**Town of Kittery  
 Planning Board Meeting  
 January 12, 2023**

**ITEM 3 – 41 Route 236 – Preliminary Site Plan Review**

**RE: Preliminary Site Plan Review – Request for Continuance  
Well Field 44 Cannabis Dispensary (Tax Map 29, Lot 1)  
41 Route 236, Kittery, Maine**

GRADING & UTILITIES PLAN  
WELL FIELD 44 CANNABIS DISPENSARY  
41 ROUTE 236, KITTELY, ME 03904

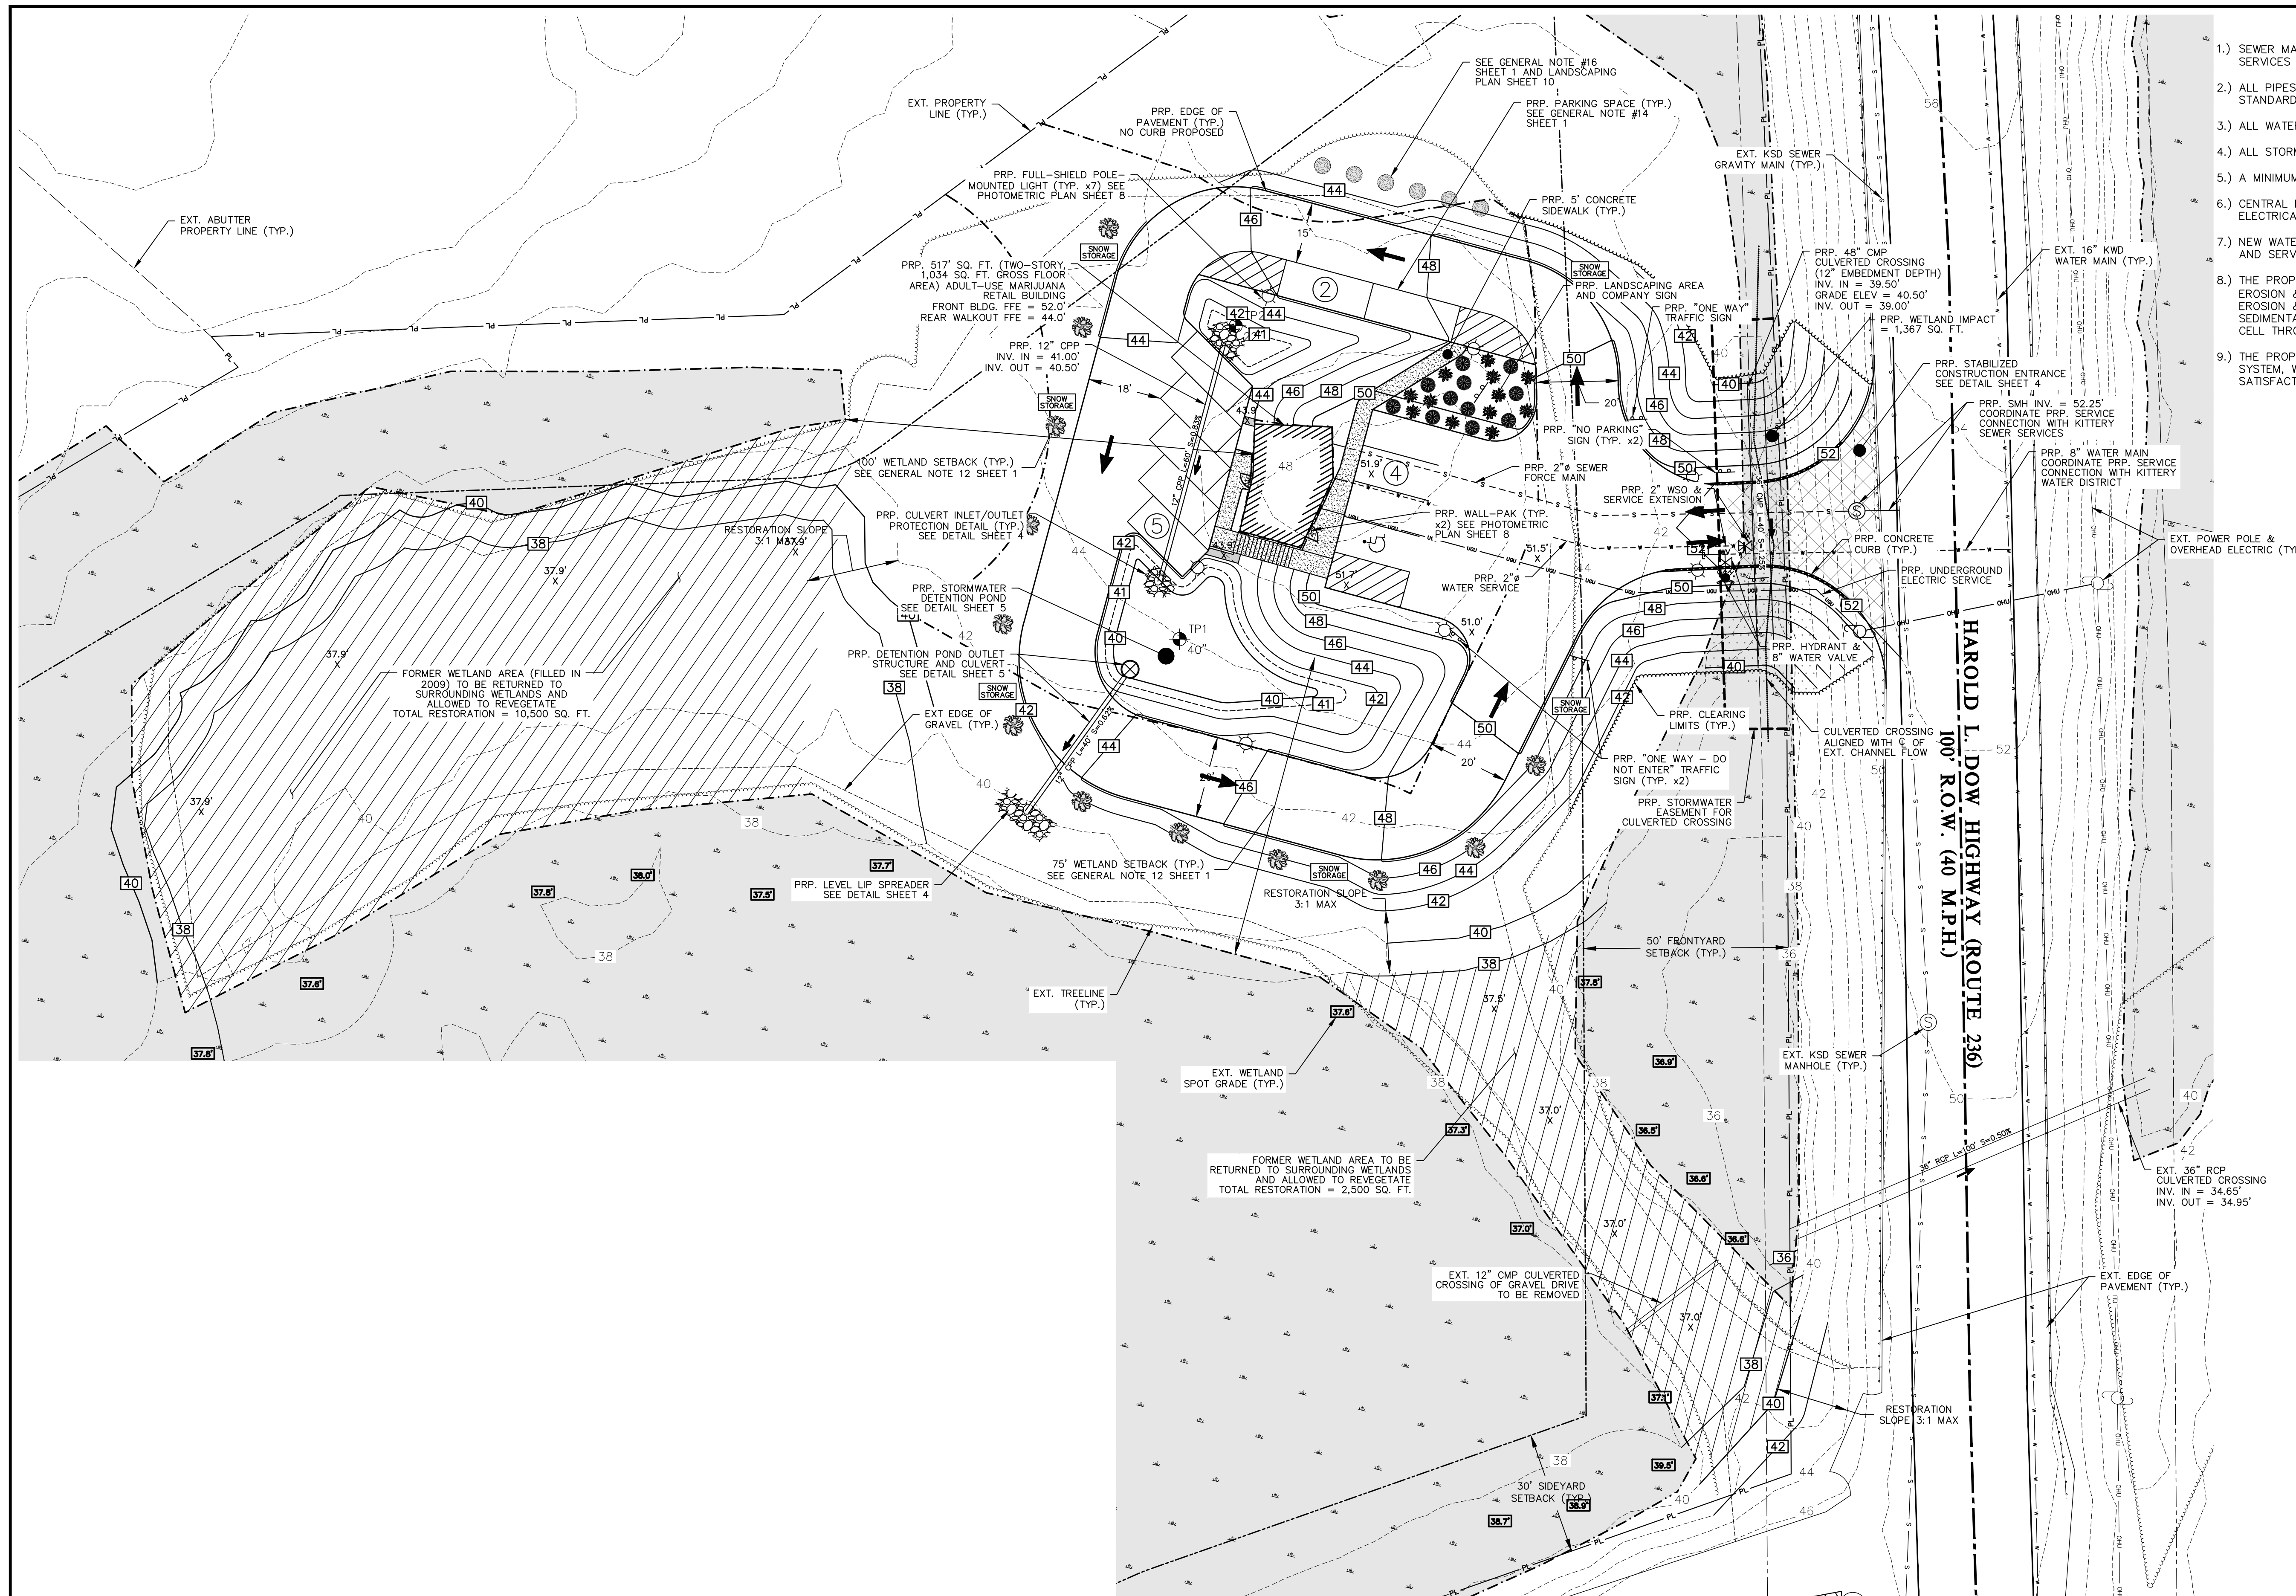
- The Grading & Utilities Plan (Sheet 3) has been updated to include the installation of a hydrant on the south side of the proposed entrance as requested by the Kittery Fire Chief. All relevant Plan Set sheets have been updated to include associated valves, shutoffs, and callouts for the appurtenances of this installation.
- Note #9 has been added to the Grading & Utilities Notes package on Sheet 3, which declares that the proposed building shall be serviced by a full NFPA 13 Fire Suppression Sprinkler System as requested by the Kittery Fire Chief. This includes monitored alarms and a keyed Knox Box which shall be located to the satisfaction of the Kittery Fire Chief.

- The Grading & Utilities Plan (Sheet 3) has been updated to have the appropriate Kittery Sewer Services references throughout.
- Correspondence with Kittery Sewer Services on the proposed extension is attached as requested.

- Grading & Utilities Notes #1 & #3 have been revised to indicate the singular sewer service and water service as requested.
- Sheet 3 has been updated to include spot grade elevations do provide more clarity to both of the small segmental block retaining walls proposed.

SITE DETAILS  
WELL FIELD 44 CANNABIS DISPENSARY  
41 ROUTE 236, KITTERY, ME 03904

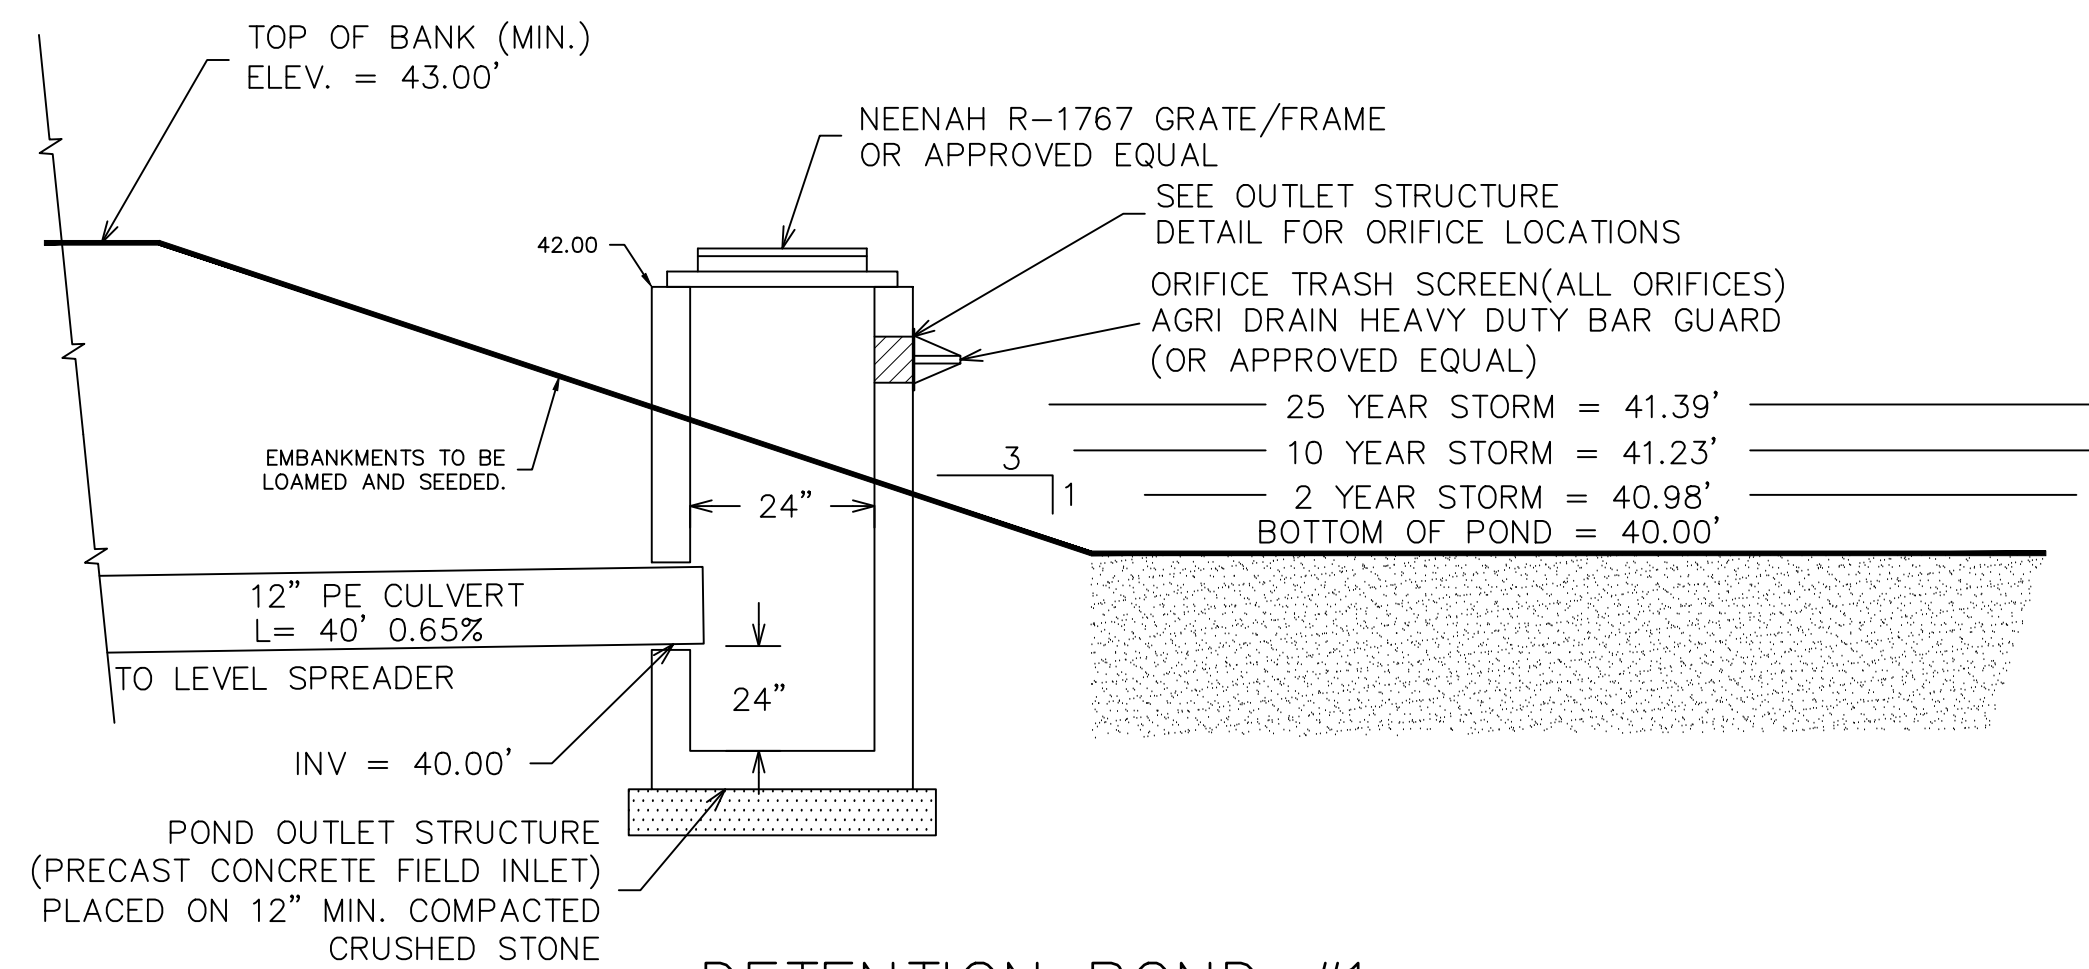
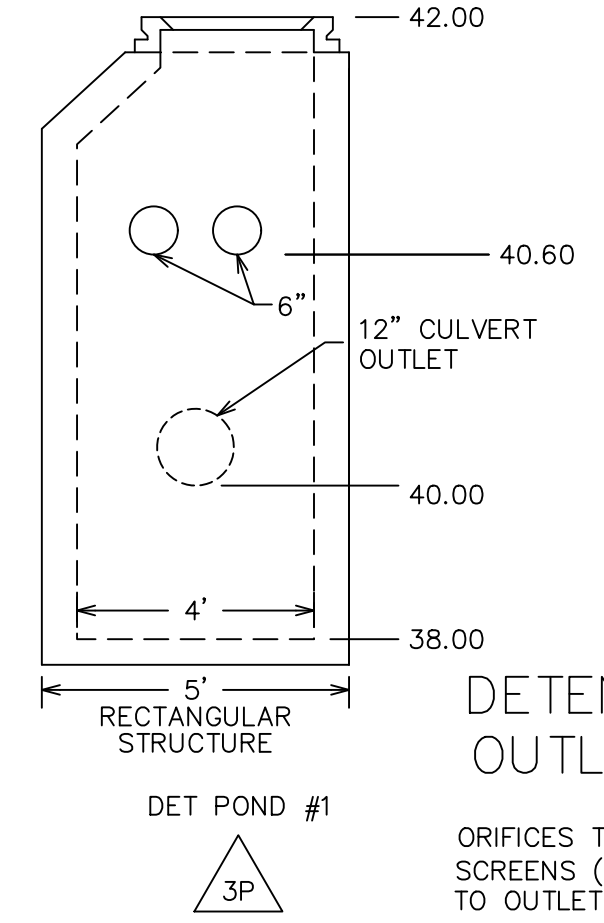
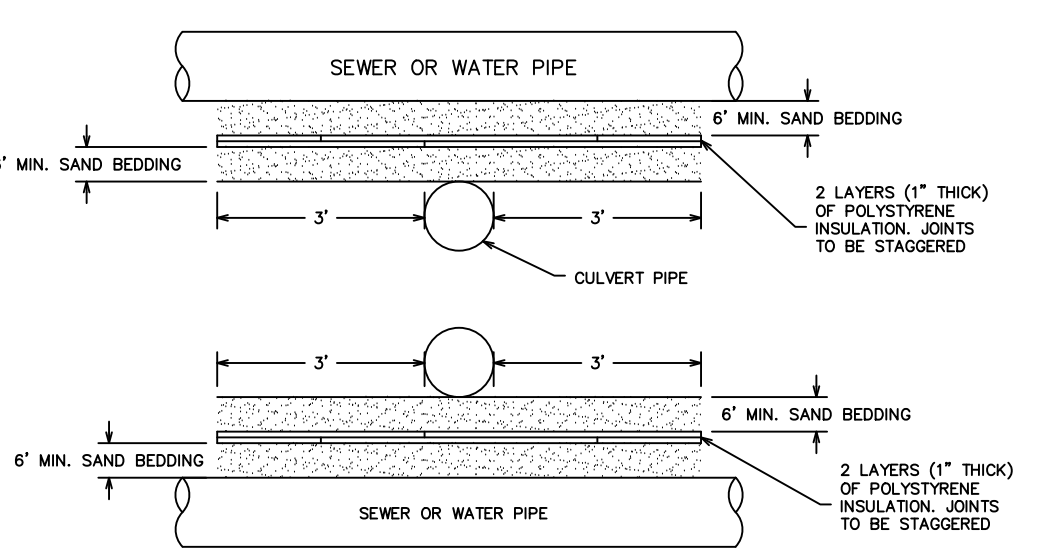
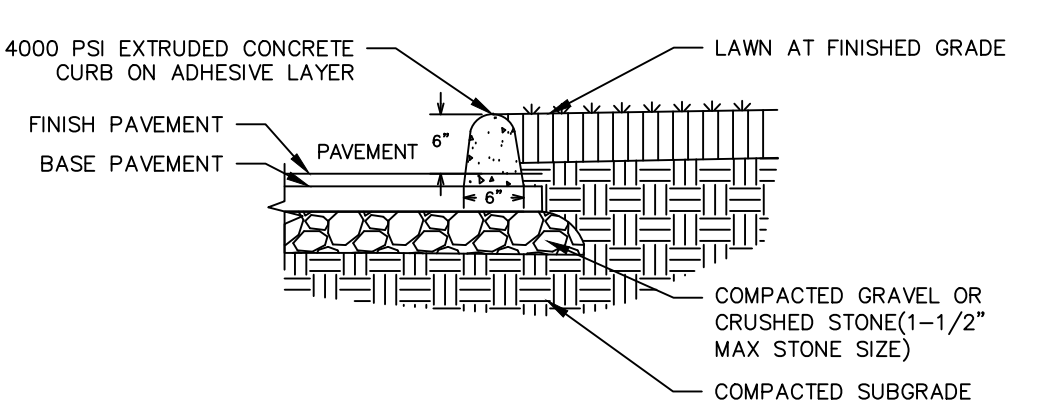
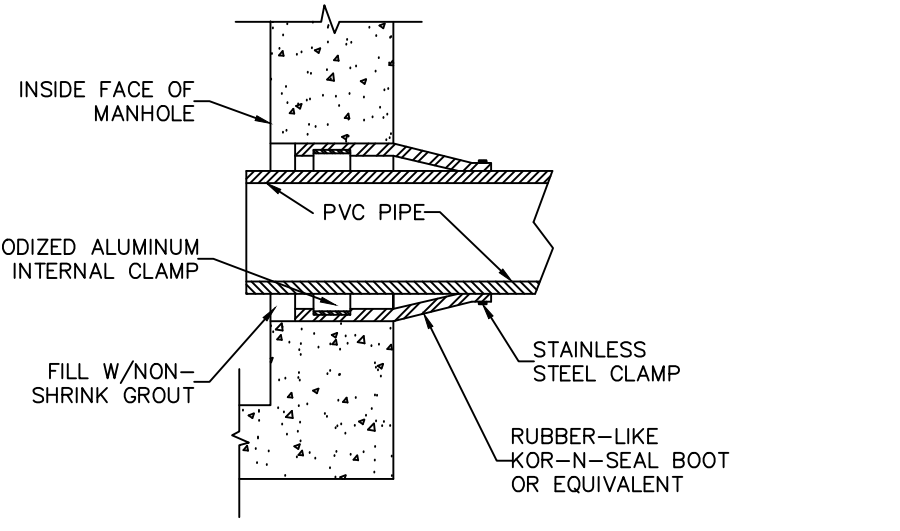
- Concrete curbing is proposed at the entrance that spans the culverted crossing, as depicted in the Site Details page (Sheet 5). All relevant Plan Set sheets have been updated to include callouts to this section of curbing.

- Side slopes on either side of the proposed entrance shall be established as indicated in the Road Cross Section details on Sheet 5.
- The Detention Pond #1 detail on Sheet 5 has been graphically updated to more properly depict the elevations of the outlet control structure as it relates to the top of bank.

- There are no catch basins proposed on site, and this detail has been removed from Sheet 5.
- The Typical Sanitary Manhole detail on Sheet 5 has been updated to include notes about gravel subbase compaction.

- Sheet 5 has been updated to include a Trench Patch Detail for any utility work within the Route 236 corridor, with dimensional requirements and thicknesses to the satisfaction of the Kittery Director of Public Works.

- The Road Cross Section detail on Sheet 5 has been updated to include the proposed 48" culverted crossing of the wetlands at the entrance to the development.

STORMWATER: DEVELOPED CONDITIONS  
 WELL FIELD 44 CANNABIS DISPENSARY  
 41 ROUTE 236, KITTERY, ME 03904

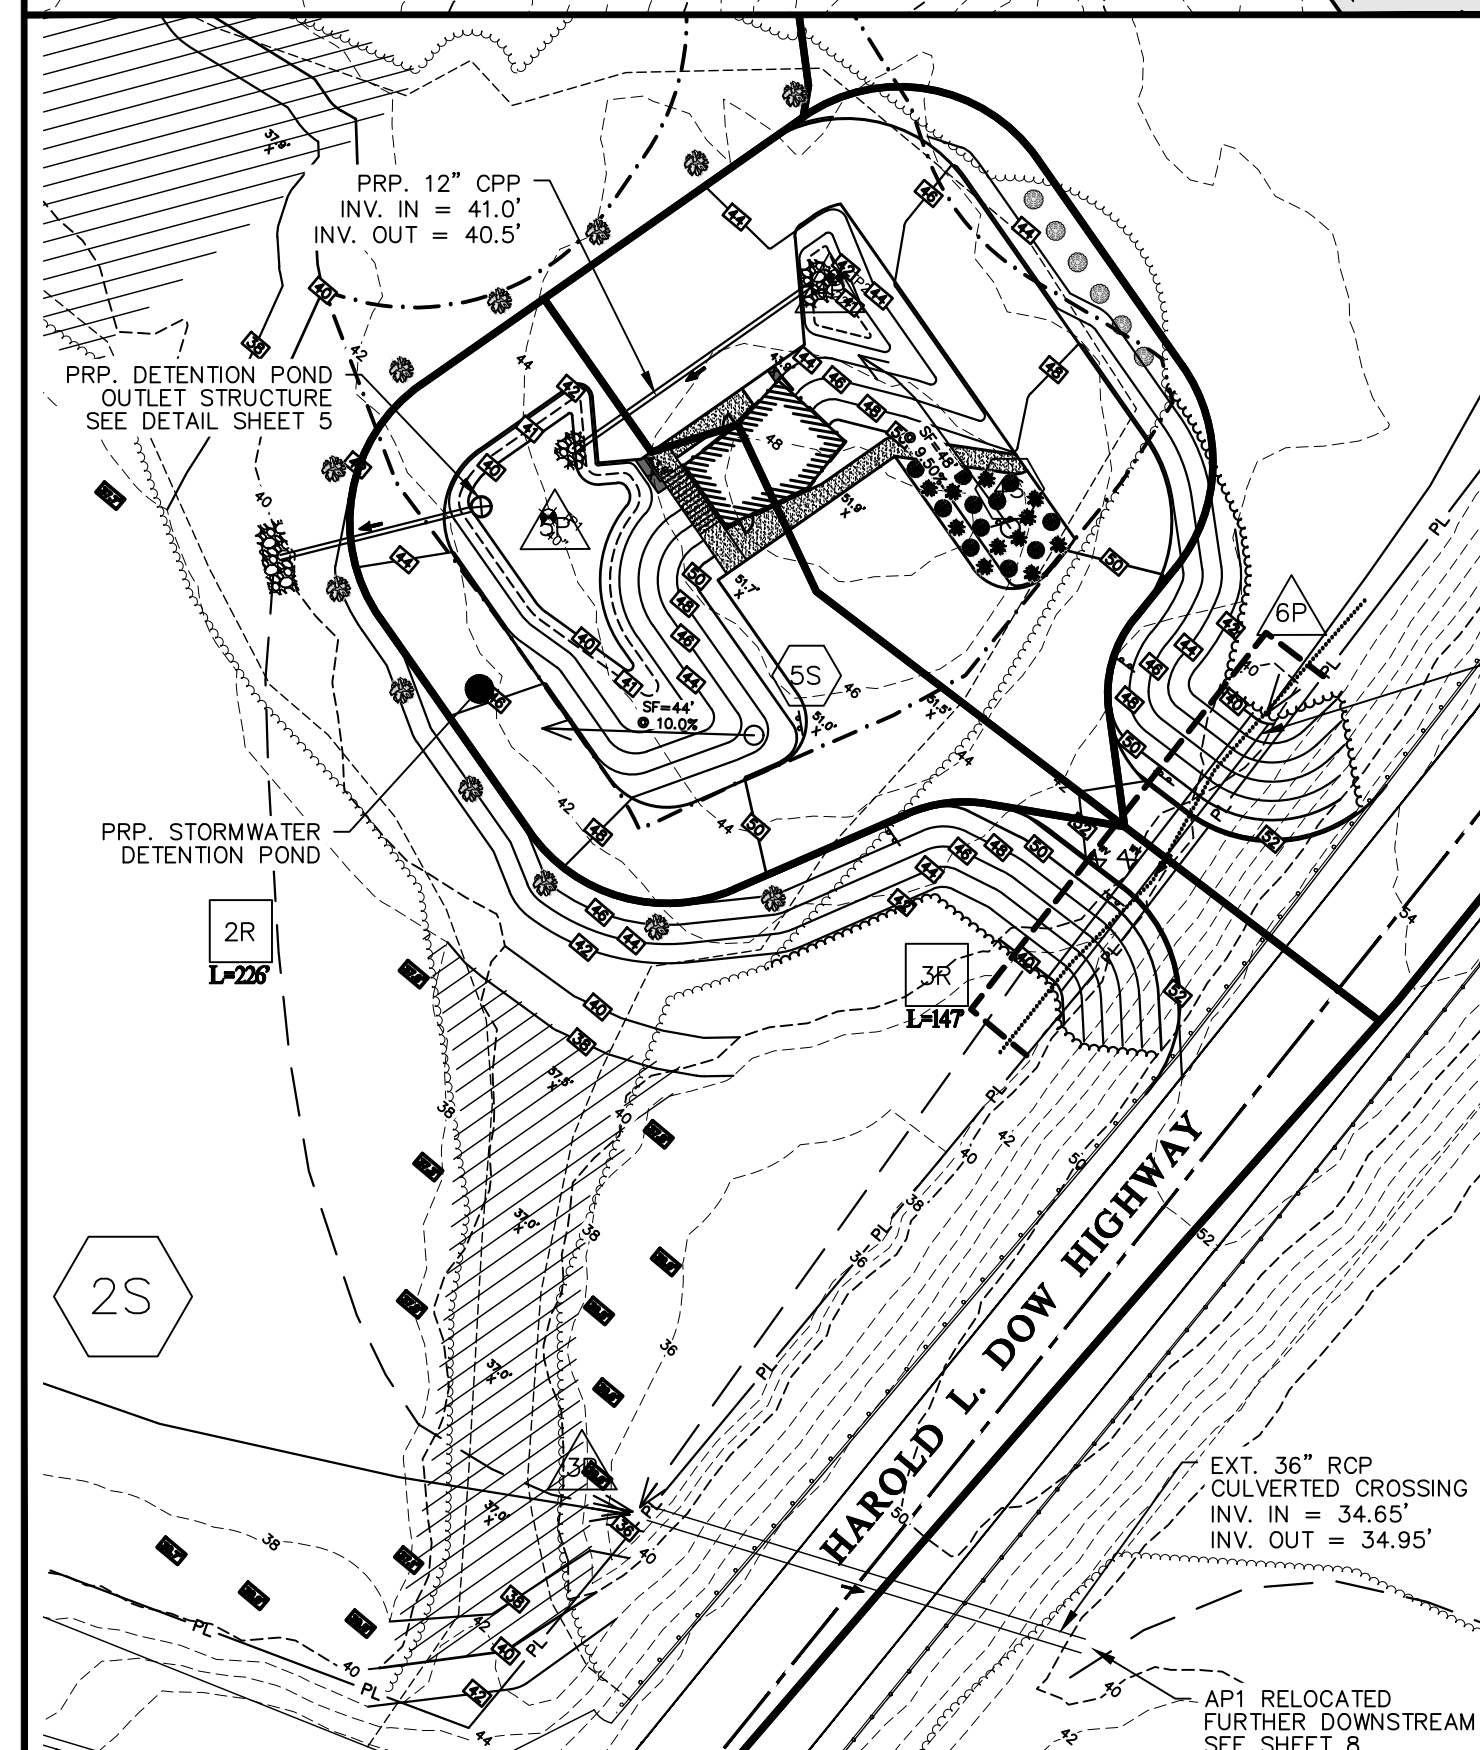
- The headwater elevation analysis previously included on the Stormwater: Developed Conditions Plan (Sheet 7) has been relocated to the Stormwater: Expanded Developed Conditions Plan (Sheet 8). This table has been updated to reflect the HydroCAD model revisions discussed above in the "§16.7.11 Performance Standards and Approval Criteria" section.

- Callouts on Sheet 7 have been updated to display the correct invert elevations for the Route 236 culverted crossing as is presented in elsewhere in the Plan Set.
